# Montecillo Unit Seven Replat "A"

City Plan Commission — April 10, 2025

CASE NUMBER/TYPE: SUSC25-00002 – Resubdivision Combination

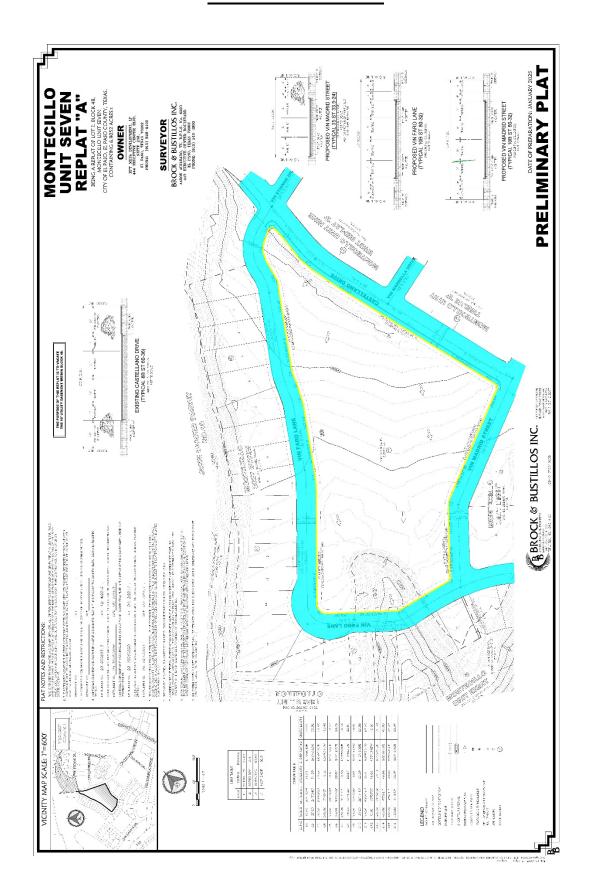
- 3. Vin Faro Lane includes two cross-sections with different proposed transition widths; however, these are not reflected on the plat. The plat currently indicates on a 50' ROW width.

Check Preliminary Plat for incorrect dimensioning (representation of) of median (0'-10' of 66' R.O.W.

Vin Madrid St. has been narrowed through this replat; make sure that these streets can still safely direct the storm sewer runoff away from this development.

We have an existing line using the 10' wide utility easement. The existing line does not have an exclusive EPE Easement, we used the easement filed on the previous plat. We ask to dedicate the 10' wide electric easement to EPE for the existing line.

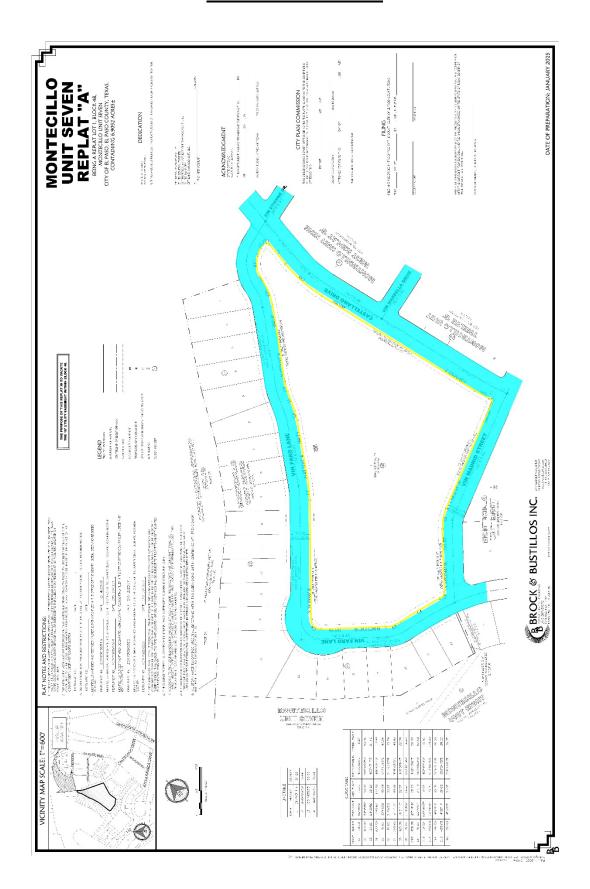
Provide a print-out of the mathematical closure of the exterior boundary of the subdivision indicating the error of closure.
